PROPOSED ALTERATIONS TO ELEVATIONS OF PLOT 4 - TRINITY VIEW, CARLETON, NPT.
6/6/25 - WIDTH OF LARGE DORMER REDUCED TO SITE CONSTRUCTION. ALSO MAIN & GARAGE ROOFS ARE TO SITE CONSTRUCTION.

DRG. REF. 4.16B

PROPOSED ALTERATIONS TO FRONT VIEW

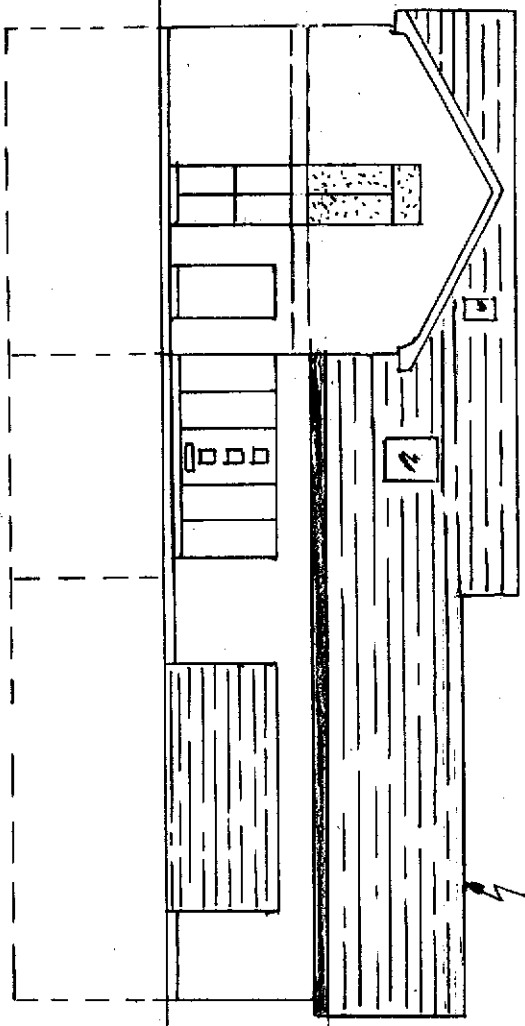
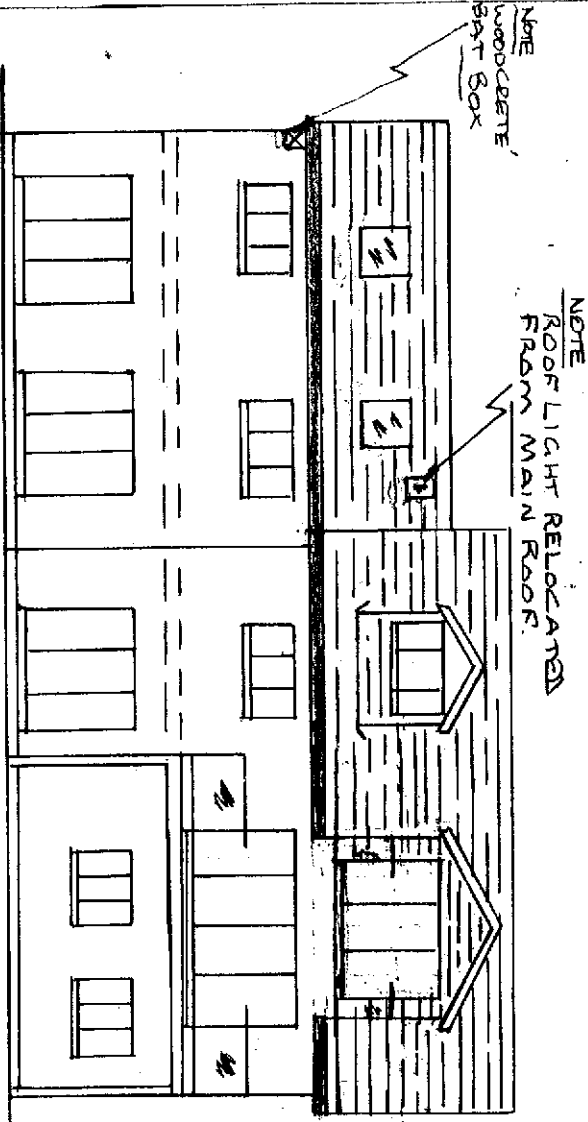
NOTE
PROPOSED RAISED ROOF
OVER GARAGE

NOTE
ROOF LIGHT RELOCATED
FROM MAIN ROOF

PROPOSED ALTERATIONS TO REAR VIEW

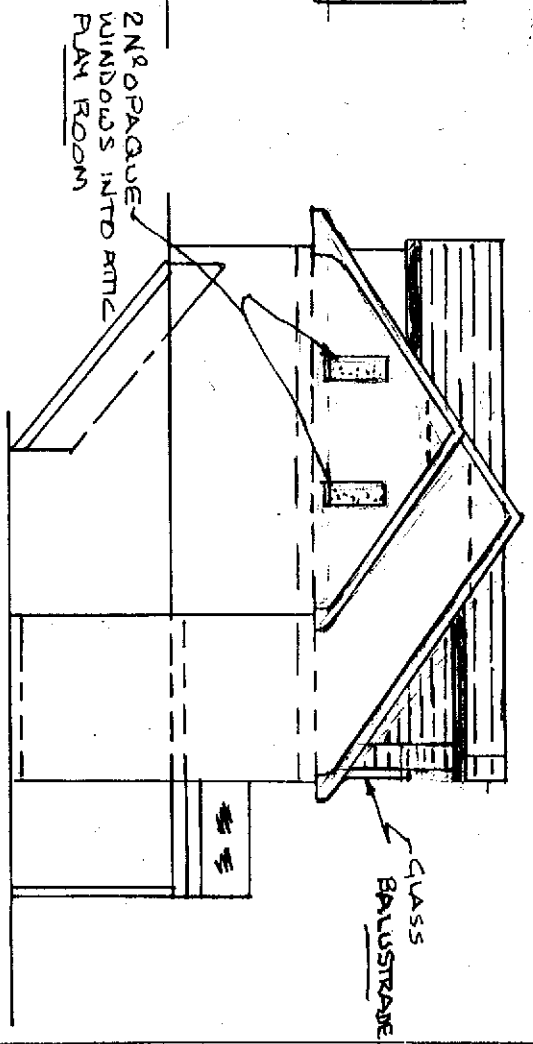
2 NO OPAQUE
WINDOWS INTO ATTIC
PLAY ROOM

PROPOSED ALTERATIONS TO LEFT VIEW

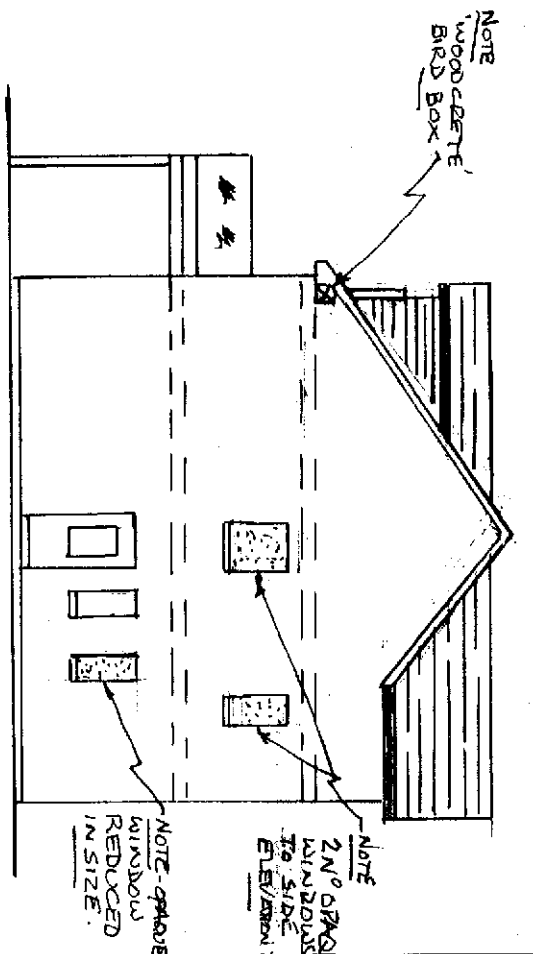
NOTE
WOODCESTRE
BIRD BOX

NOTE
2 NO OPAQUE
WINDOWS
TO SIDE
ELEVATION

NOTE - OPAQUE
WINDOW
REDUCED
IN SIZE.
